UNITED STATES PATENT AND TRADEMARK OFFICE

APPLICATION NO.	FILING DATE	FIRST NAMED INVENTOR	ATTORNEY DOCKET NO.	CONFIRMATION NO.
10/667,535	09/22/2003	Paul F. Illegems	5707-0410	9954
7590	06/30/2005			
Jeffrey C. Hood Meyertons, Hood, Kivlin, Kowert & Goetzel PC P.O. Box 398 Austin, TX 78767				
EXAMINER				
ENGLUND, TERRY LEE				
ART UNIT		PAPER NUMBER		
2816

Office Action Summary

DETAILED ACTION

FIG. 7

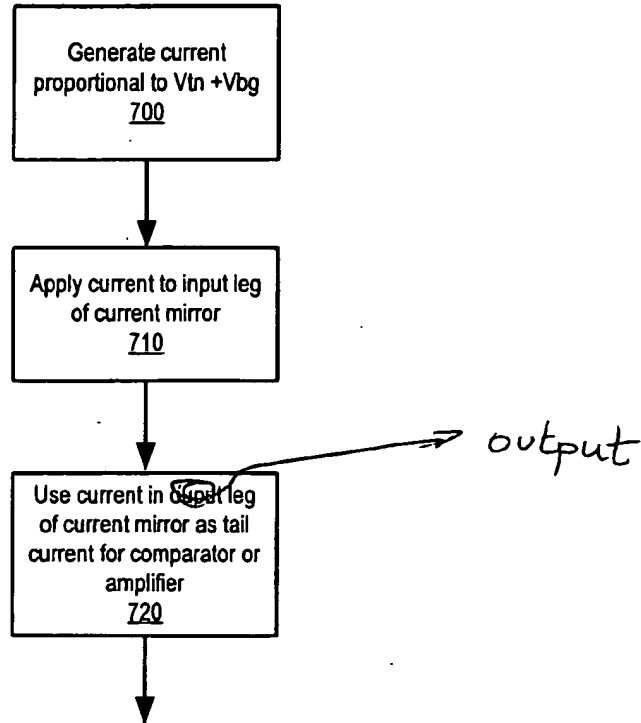
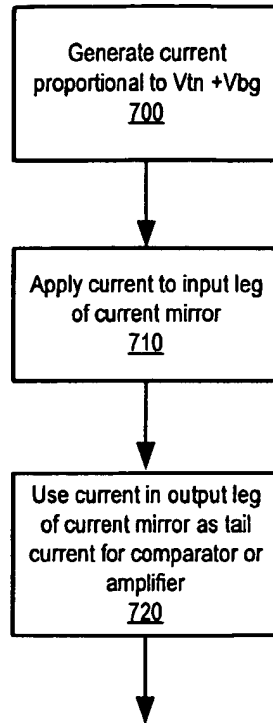
The replacement sheet for Fig. 7 has been approved by the examiner. It overcomes its typo related objection, which has now been withdrawn.

The attached replacement sheet contains a formal drawing that includes changes to FIG. 7. This sheet replaces the originally filed sheet containing the same figure.

Approved
6.23.05
TLE
